Panel Report

Yarra Planning Scheme Amendments C218 and C219

Rezoning of sites in Trenerry Crescent, Abbotsford

25 October 2017

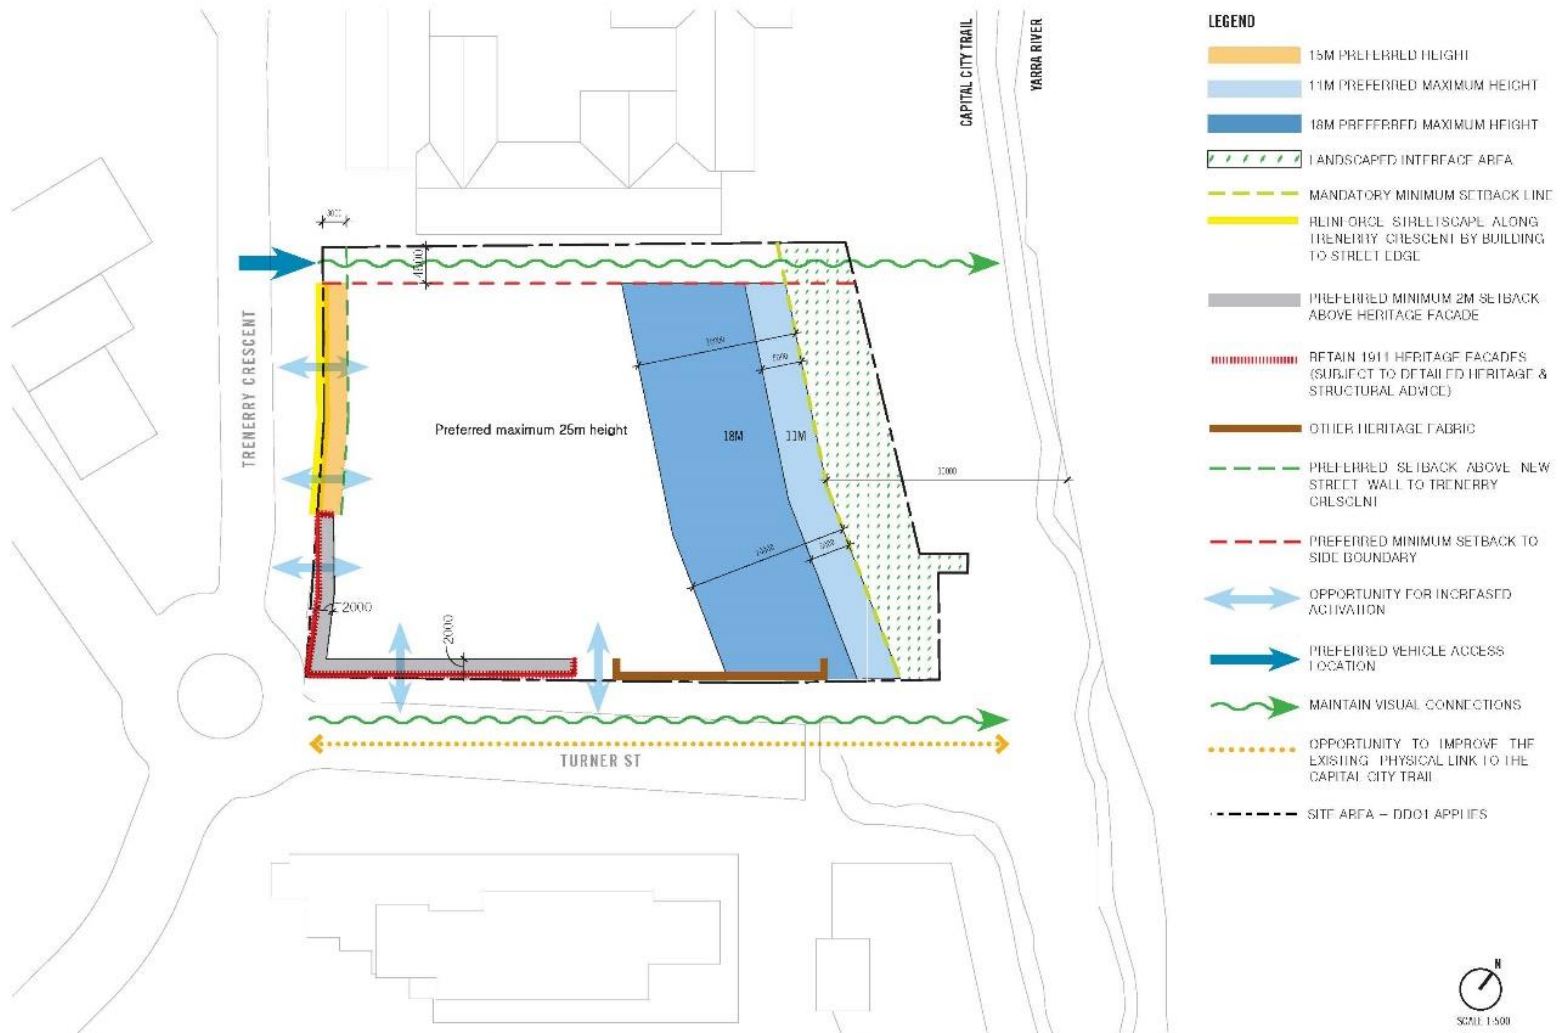
- Retain the identified heritage façades shown on the 18-62 Trenerry Crescent Framework Plan in Figure 1 and where appropriate, other elements of the heritage fabric to provide a contextual link to the historical industrial uses along Trenerry Crescent.
